Roseville College – Sport and Wellbeing Centre (SSD-9912)

Additional Material

Figure 5.15
Revised design perspective 02 aerial view looking south west.
Source: Brewster Hjorth Architects

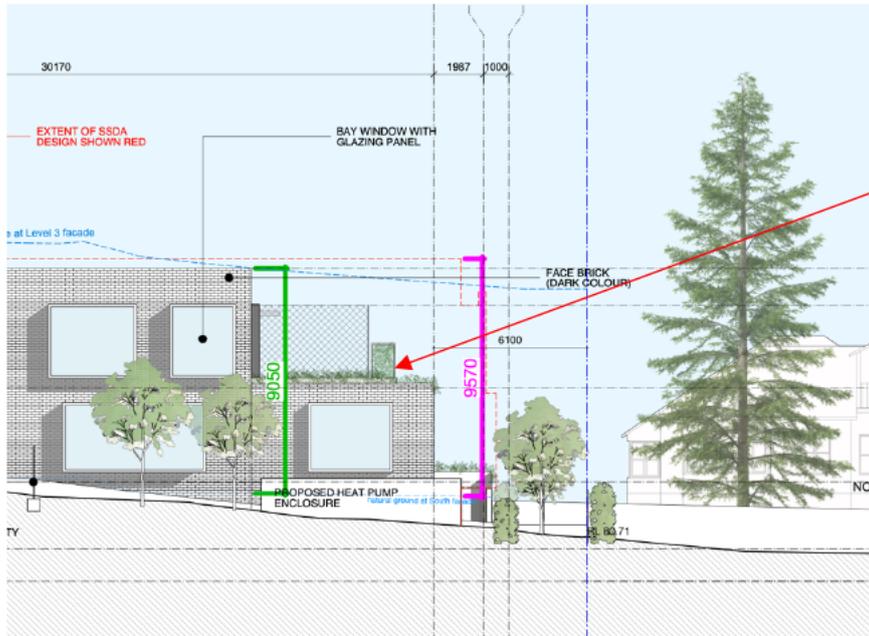
“Green screen’ will only cover the lower half of the barrier and court fence, leaving the top half fully exposed to view on all three sides of the development, with the chain wire fence visible above the barrier

No ‘green screen’ covering the barrier and court fence on the Western side. Barrier is fully visible from the Western end of Bancroft Avenue. The barrier will be in full view, without screening on the NW corner – approx. 30 metres in each direction

Significant gap in 'green screen' at North East corner, fully exposing barrier to view

"Green screen" covers less than 50% of Bancroft Street frontage. Barrier will be fully visible in much Bancroft Avenue (plus the Western side barrier will be fully visible with no screening)
